CALIFORNIA CENTRAL VALLEY
FLOOD CONTROL
 ASSOCIATION

October 30, 2015

Subject: CCVFCA Comments on the Partially Recirculated Bay-Delta Conservation Plan EIR/EIS with New CA WaterFix Sub-Alternatives

Figure 22. Alt 4-ELT North Delta Diversion Versus South Delta Diversion for July, August, and September

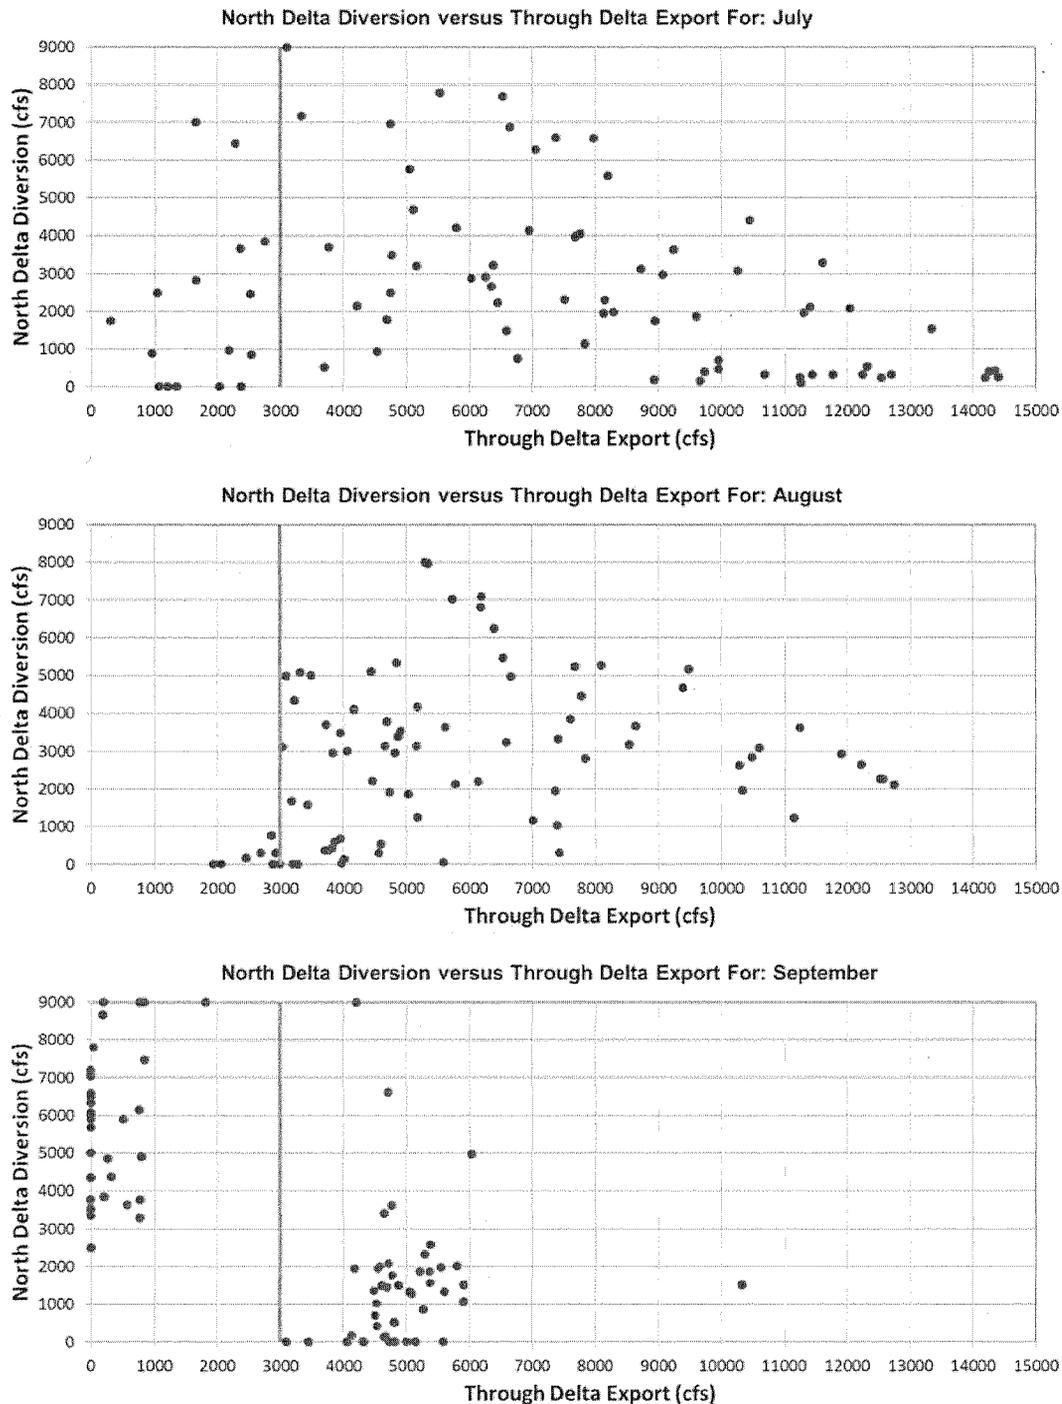
Figure 22 contains figures for July, August, and September for Alt 4-ELT that plot NDD against SDD. In the months of July to September SDD are occasionally very high, exceeding 14,000 cfs in July, with minimal NDD. This occurs due to outdated model code that imposes an instream flow requirement in Sacramento River flow below Hood in excess of the bypass criteria prescribed in the BDCP. There are numerous occurrences when bypass flows prescribed in the BDCP are exceeded and SDD are higher than expected. On the other hand, there are also many times when NDD are above minimum pumping levels and SDD are below the BDCP prescribed 3,000 cfs threshold indicated by the green line in Figure 22. Alt 4-ELT North Delta Diversion Versus South Delta Diversion for July,

August, and September. For unknown reasons, the model code requiring SDD to be greater than 3,000 cfs before NDDs occur from July through September is deactivated in the BDCP modeling of this Alternative.

Figure 23. South Delta Diversion at Banks

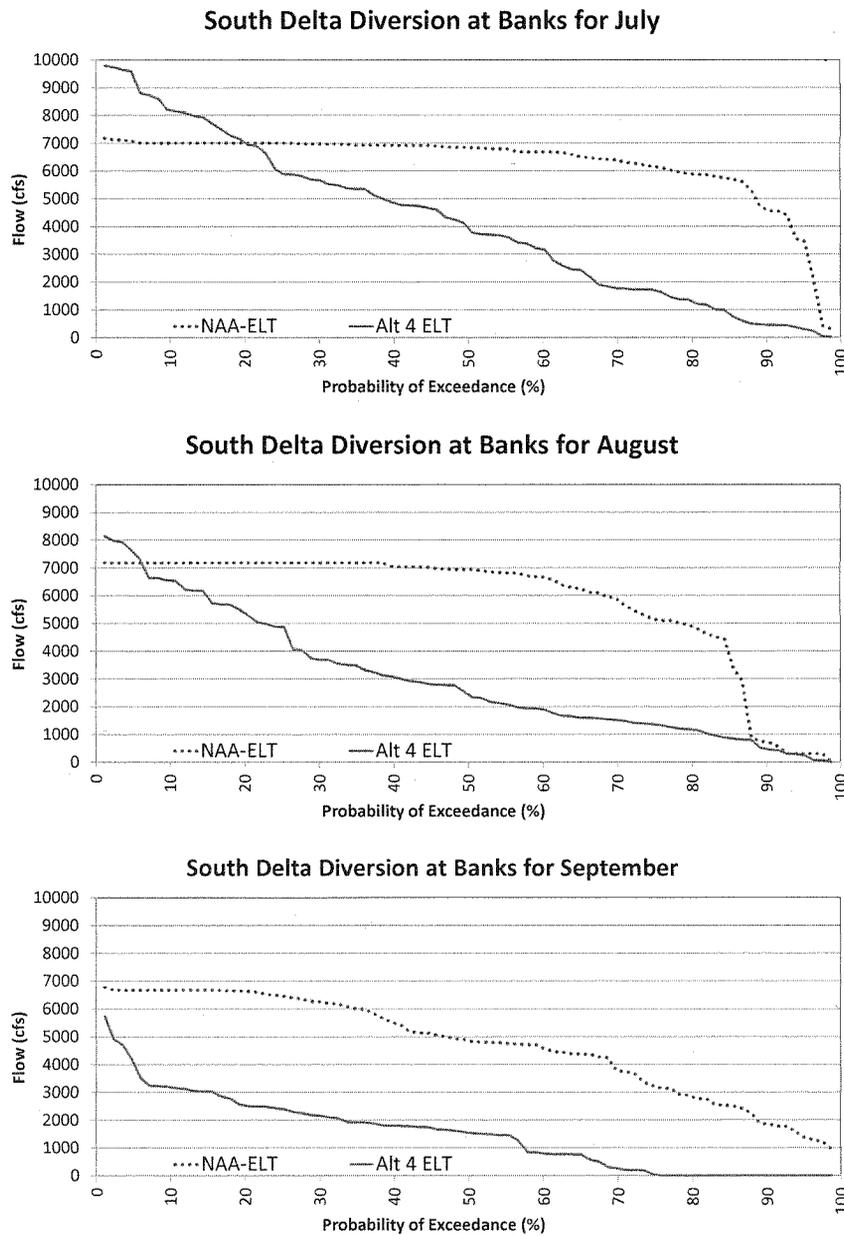
South Delta Diversion at Banks is not limited to existing permit capacity of 6,680 cfs and pumping may reach full capacity of 10,300 cfs in July, August, and September. Figure 23 contains exceedance probability charts of South

Delta Diversion at Banks for July, August, and September. The chart for July shows SDD at Banks exceeding existing permit capacity 20% of years, in August this occurs in about 7% of years. There are South Delta diversions at Banks 25% of the time in September while diversions from the Sacramento River may range from 2,500 cfs to 7,500 cfs.

Figure 38. Sacramento River Temperature at Bend Bridge NAA-ELT and Alt 4-ELT

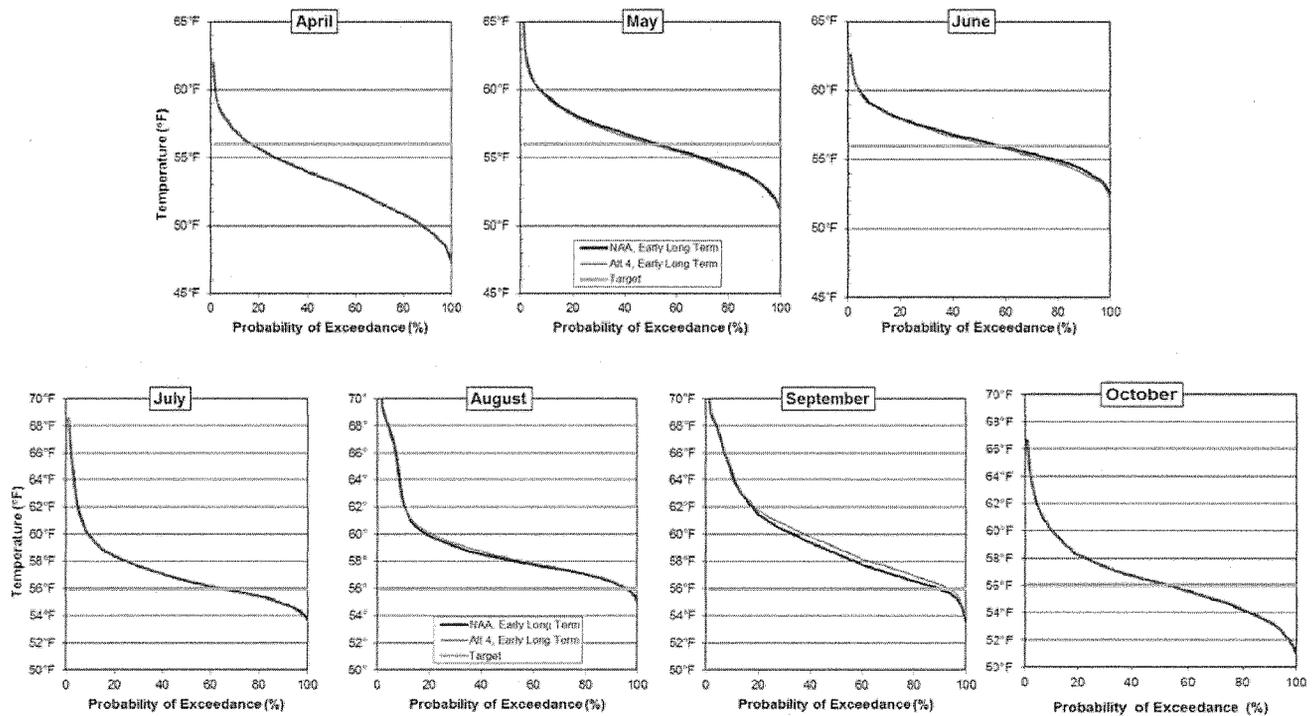
Figure 38 contains exceedance probability plots of Sacramento River temperature at Bend Bridge for the NAA-ELT and Alt 4-ELT. For the months of April through July modeling shows few changes in upper Sacramento River water temperature. The Alt 4-ELT scenario shows temperature increases in August relative to the NAA-ELT. In about 75% of years modeling shows about 0.5°F increase in Alt 4-ELT relative to the NAA-ELT. The temperature models will meet inputted target temperatures until Shasta Lake cold water is depleted, this typically occurs in September. This is the likely reason temperature increases in modeling tend to occur in September.

Figure 43. Change in Conveyance Source of Exports (Alt 4 minus FNA)

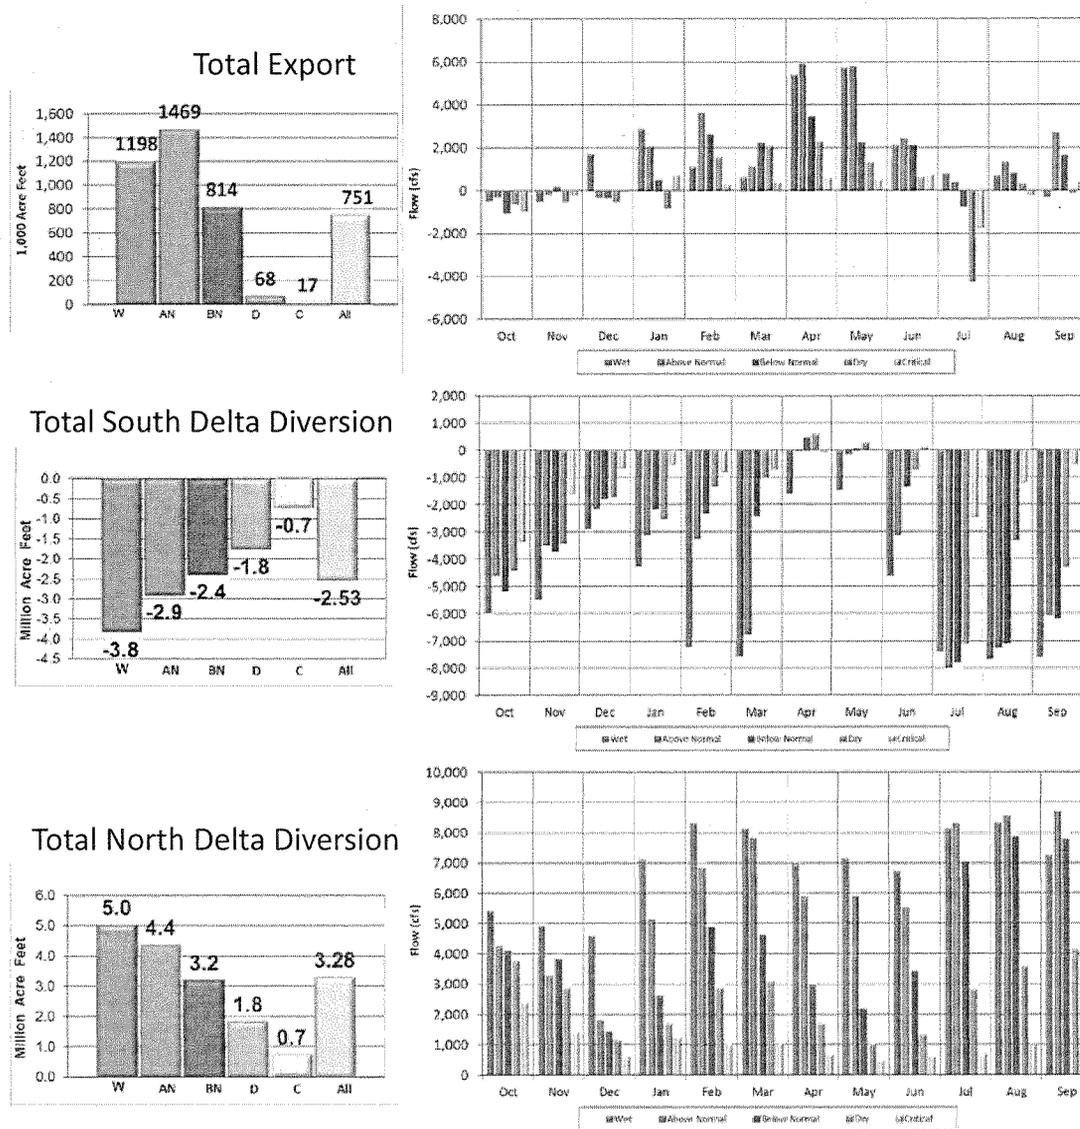
Changes in total, South Delta, and North Delta exports are displayed in Figure 43. Average annual increase in total Delta exports is about 750 TAF, the increases primarily occur in wetter year types with lesser increases in dryer years. South Delta export decreases about 2.53 MAF in Alt 4 relative to the FNA. Export through the NDD is 3.28 MAF in Alt 4, about 58% of total exports are diverted from the North Delta.

Figure 61. Sacramento River below Hood

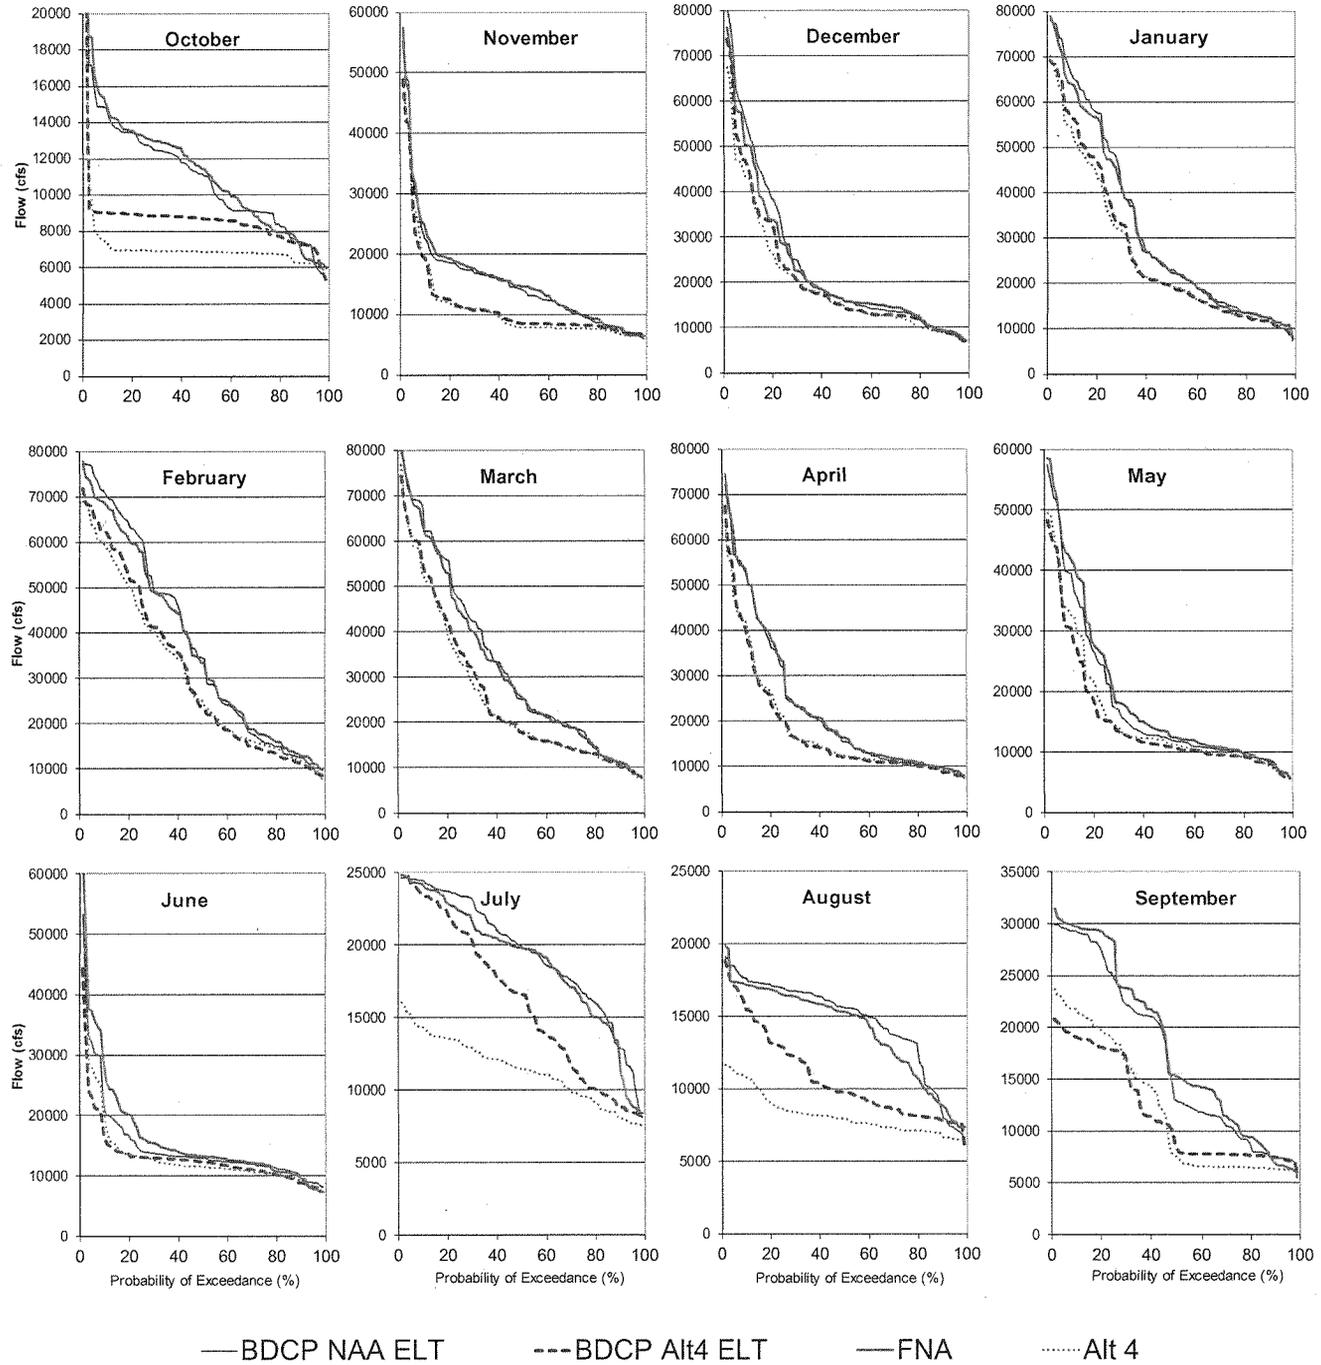
Figure 61 contains monthly exceedance probability plots for Sacramento River below the NDD for the following scenarios: 1) BDCP NAA-ELT, 2) BDCP Alt 4-ELT, 3) independent modeling FNA, and 4) independent modeling Alt 4. The most significant differences in flow changes occur in October, July, August, and September. Changes in Sacramento River flow entering the Delta are a key indicator of changes in interior Delta flows, water levels, and water quality.

In the independent modeling September flows are reduced by about 6,100 cfs while BDCP modeling shows a reduction of about 5,300 cfs. The independent modeling shows Sacramento River flow entering the Delta to be about 7,000 cfs 50% of the time, BDCP modeling show Sacramento River flow is about 8,000 cfs 50% of the time.
